**NAPERVILLE PLANNING AND ZONING COMMISSION
COUNCIL CHAMBERS – MUNICIPAL CENTER
FINAL AGENDA
08/08/2012 - 7:00 p.m.**

1. PC Case # PZC 12-1-039 and PZC 12-1-040 Water Street District - North Phase/South Phase
Petitioner: MP Water Street District, LLC, 410 S. Main Street, Naperville, IL
Location: The subject site is located in the Water Street District, which is bounded by Aurora Avenue on the south, DuPage River on the north, Main Street on the east, and Webster Street on the west.

NAPERVILLE PLANNING AND ZONING COMMISSION AGENDA ITEM

RE: The Water Street District – Response to Issues and Questions

**THEATER AND LOGGIA
ELEVATIONS**

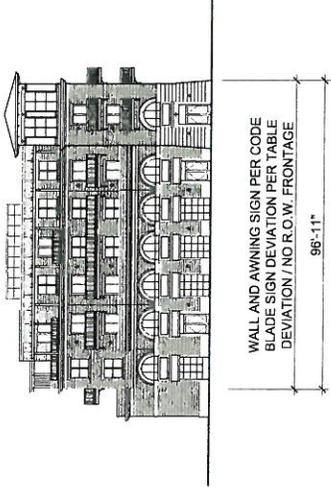
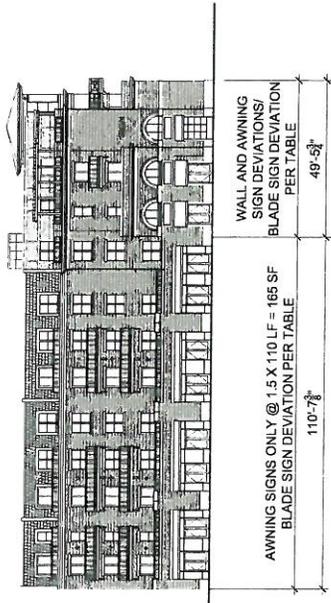
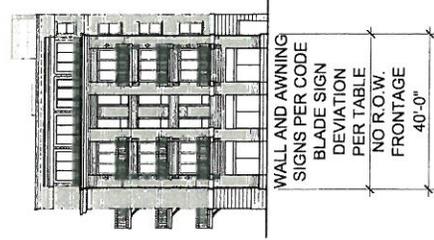
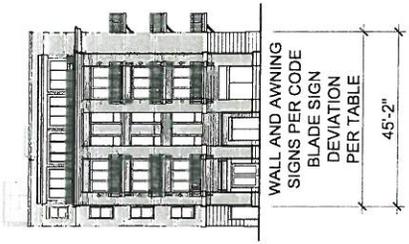
- Loggia Building: staff finds that the number and location of the 17 balconies proposed, particularly those located along the 2nd floor, will inhibit the pedestrian experience along Water Street. Accordingly, staff has recommended that the petitioner remove the 2nd floor overhanging balconies located in the center portion of the building (4 total). The petitioner is agreeable to the removal of the overhanging balconies and instead proposed "juliet" balconies which are essentially flush against the building's facade.

It should be noted that the 8 balconies proposed at the center of the building will have the greatest encroachment at 5' overhang into the Water Street right-of-way. Due to the building's modulation, the balconies proposed at the southwest corner of the building along Water Street will encroach approximately 3' and those at the southeast corner of the building will encroach approximately 4'. This staggered encroachment pattern will provide some variation along the building's facade, thus reducing the monotonous appearance of the overhanging balconies.

- Theater Building: staff finds that the 6 balconies proposed add to the building's symmetry and design aesthetic. Given the building's narrow width, staff has no concerns with these proposed balconies.

On the Water Street frontage, we had proposed seventeen balconies on the Loggia Building and six balconies on the Theatre Building. Based on discussions with City staff, we have revised the facade of the Loggia Building to provide overhanging balconies on only the third and fourth floors; the second and fifth floors will only have juliette balconies. (Building/Streetscape Rendering – Attachment 7). The overhanging balconies vary in size (Balcony Information – Attachment 8). The third floor balconies will be approximately 24 feet 6 inches above the sidewalk.

BUILDING THREE: HOTEL ELEVATIONS

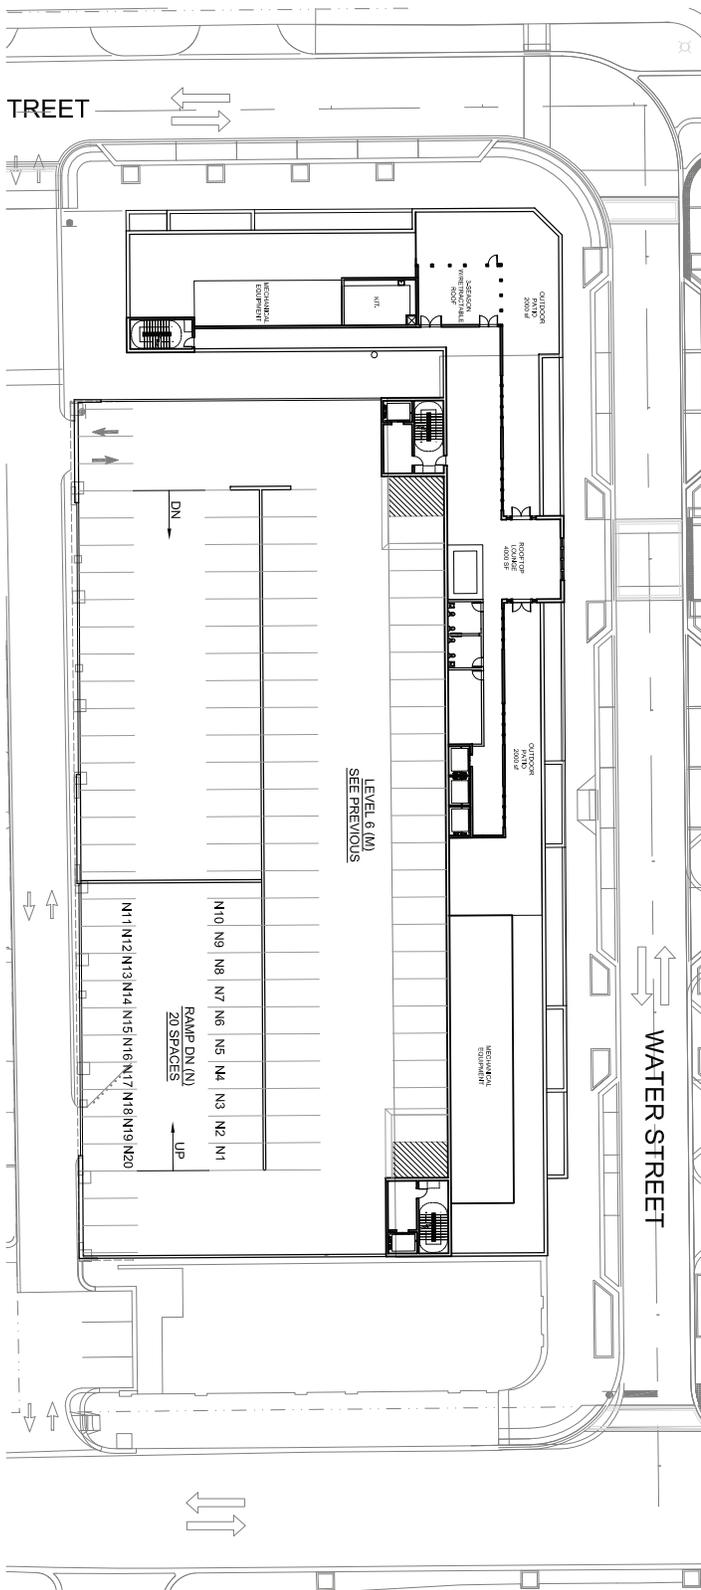
Staff has continued to work with the petitioner on this issue since the June 20th PZC meeting. Given that the petitioner has reduced the height of the westernmost accent towers on this building, staff finds that the stone material will continue to serve as an accent material on the pedestrian-level facade (1st through 4th floors) and not dominate the building's facade. Staff supports the revised Hotel elevations as proposed (see Attachment 8).
